PROJECT TYPICAL SECTIONS

PROJECT NAME:	CRAFTSBURY	PLOT DATE:	04-JUN-2009
PROJECT NUMBER:	BRO 1449 (24)	DRAWN BY:	G. ROY
DESIGNED BY:	G. ROY	CHECKED BY:	W. LAMMER
FILE NAME:	96J310/str/sj310typ.dgn		
PROJECT MANAGER:	R. R. WHITCOMB		
sj310typ.i			SHEET 7 OF 47

BRIDGE TYPICAL SECTION

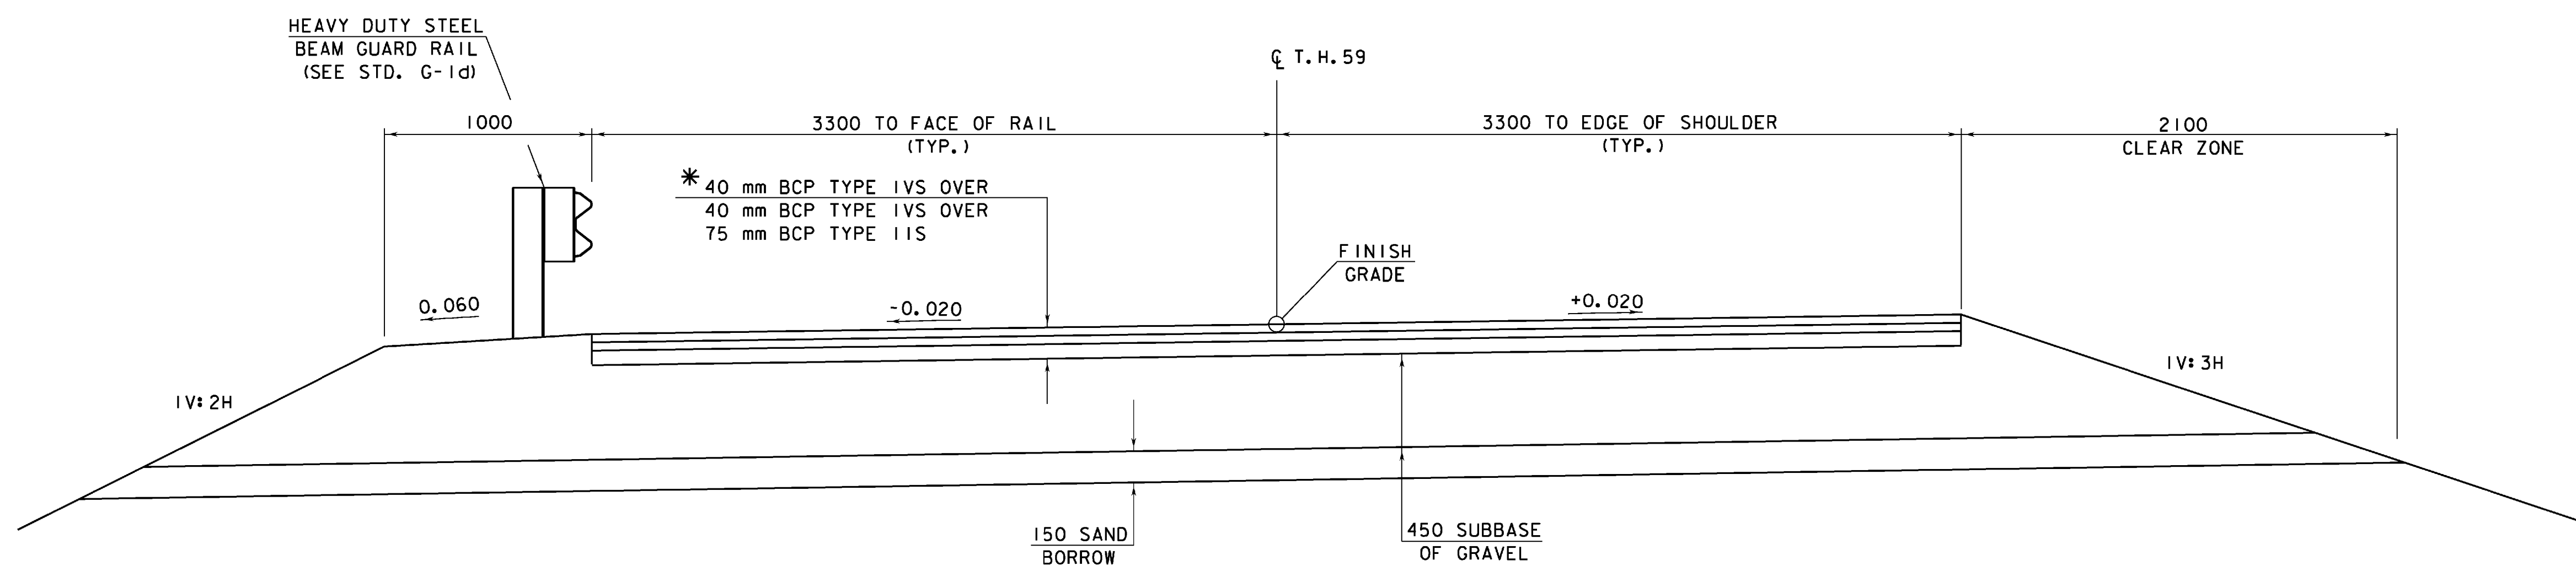
AT THE REQUEST OF THE CONTRACTOR THE 300 OF GBFFS WAS MODIFIED TO 200 OF GBFFS BELOW A 100 CONCRETE PAD, FOR FORMING THE ABUTMENT. CONCRETE PAID AS GBFFS
